Addendum 1
File # 17-05AA
Project: DWP Site Restoration - Earthwork

**DWP SITE RESTORATION
PHASE II - EARTHWORK**
CITY OF DULUTH,
MINNESOTA

SHEET KEY	
SHEET TITLE	
PLAN - SOUTH SIDE	
DATE:	3/20/17
DRAWN BY:	MSD
CHECKED BY:	LWS
PROJECT NUMBER	15240
SHEET NUMBER	L-2

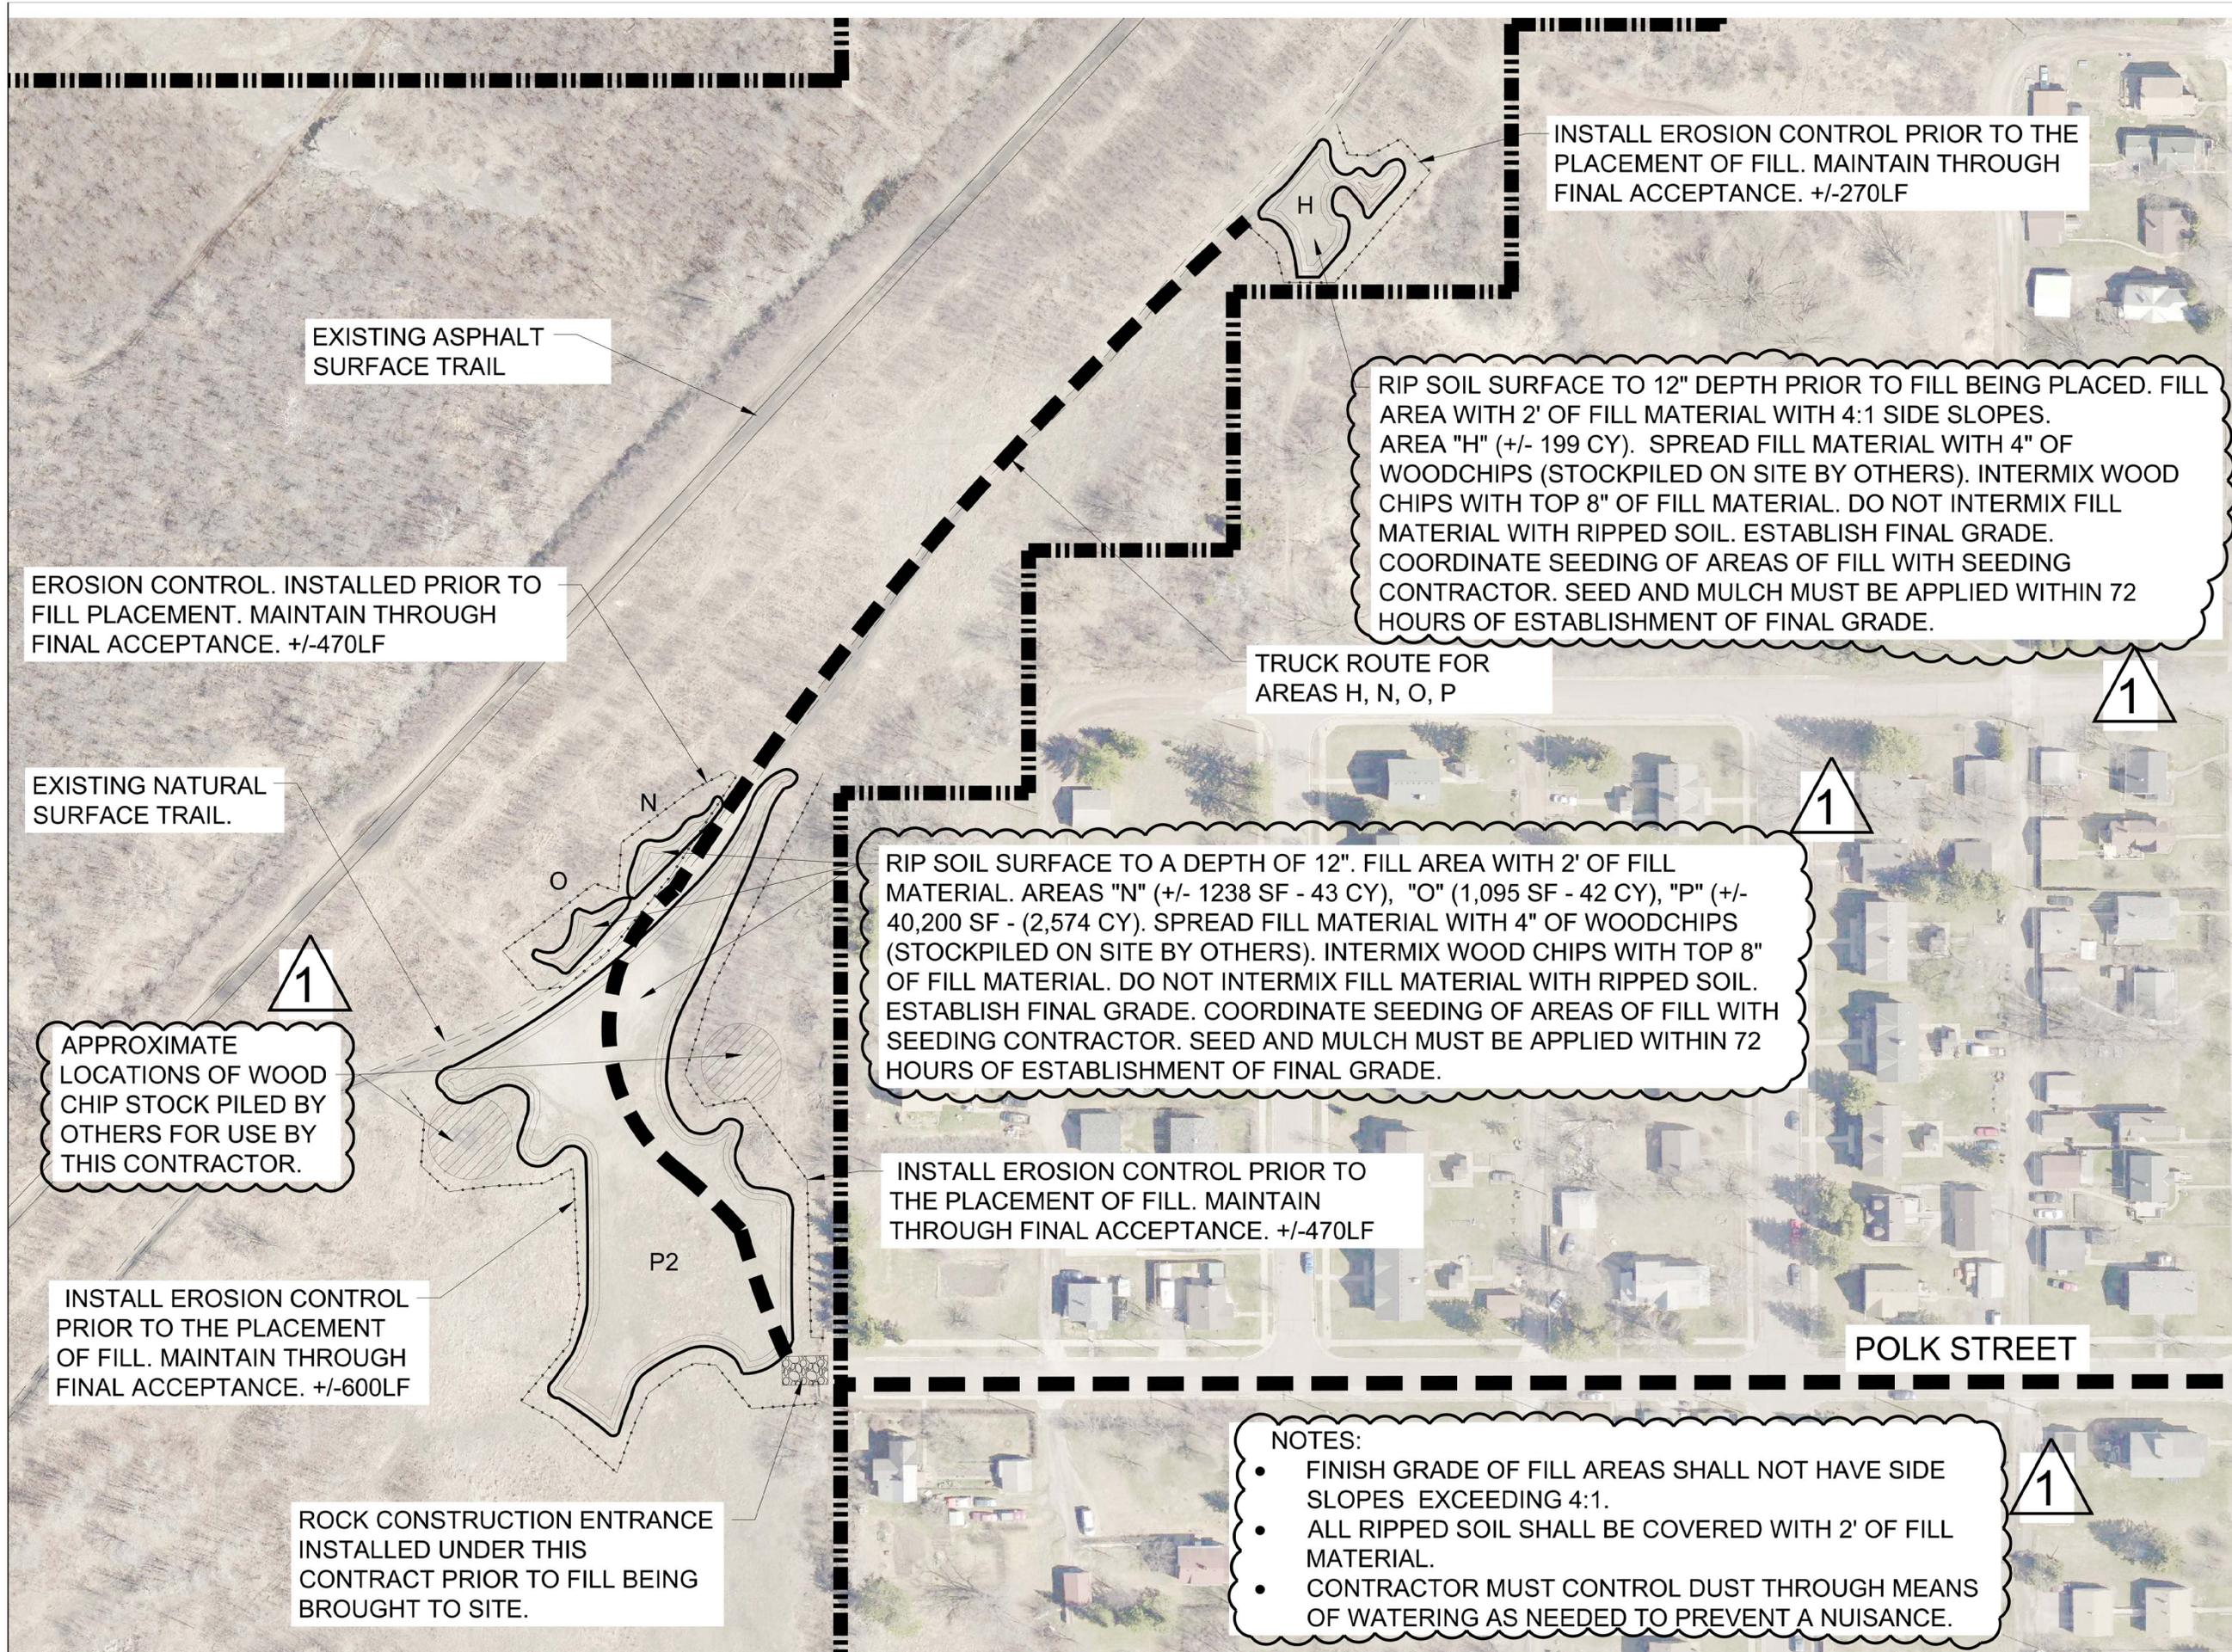
3. Sheet L-2 has been revised and is attached. Changes are identified by "1."
4. The following questions are answered below:
 - a. Q1 – Are there any specific requirements or training needed to be on US Corp of Engineer's property at Erie Pier?
A1 – Contractor is responsible for coordinating with, and meeting all conditions and requirements of the US Corp of Engineers.

- d. Q4 - The definition of bid items, Bid Item #4, describes the fill material to be intermixed with wood chips. I see no additional information in the plans. Is there any additional information regarding the wood chips?
Type, quantity, ratio of mixture?
A4 – See revised sheet L-2 for clarification on wood chips.

APPROXIMATE LOCATIONS OF WOOD CHIP STOCK PILED BY OTHERS FOR USE BY THIS CONTRACTOR.

RIP SOIL SURFACE TO 12" DEPTH PRIOR TO FILL BEING PLACED. FILL AREA WITH 2' OF FILL MATERIAL WITH 4:1 SIDE SLOPES. AREA "H" (+/- 199 CY). SPREAD FILL MATERIAL WITH 4" OF WOODCHIPS (STOCKPILED ON SITE BY OTHERS). INTERMIX WOOD CHIPS WITH TOP 8" OF FILL MATERIAL. DO NOT INTERMIX FILL MATERIAL WITH RIPPED SOIL. ESTABLISH FINAL GRADE. COORDINATE SEEDING OF AREAS OF FILL WITH SEEDING CONTRACTOR. SEED AND MULCH MUST BE APPLIED WITHIN 72 HOURS OF ESTABLISHMENT OF FINAL GRADE.

RIP SOIL SURFACE TO A DEPTH OF 12". FILL AREA WITH 2' OF FILL MATERIAL. AREAS "N" (+/- 1238 SF - 43 CY), "O" (1,095 SF - 42 CY), "P" (+/- 40,200 SF - (2,574 CY). SPREAD FILL MATERIAL WITH 4" OF WOODCHIPS (STOCKPILED ON SITE BY OTHERS). INTERMIX WOOD CHIPS WITH TOP 8" OF FILL MATERIAL. DO NOT INTERMIX FILL MATERIAL WITH RIPPED SOIL. ESTABLISH FINAL GRADE. COORDINATE SEEDING OF AREAS OF FILL WITH SEEDING CONTRACTOR. SEED AND MULCH MUST BE APPLIED WITHIN 72 HOURS OF ESTABLISHMENT OF FINAL GRADE.
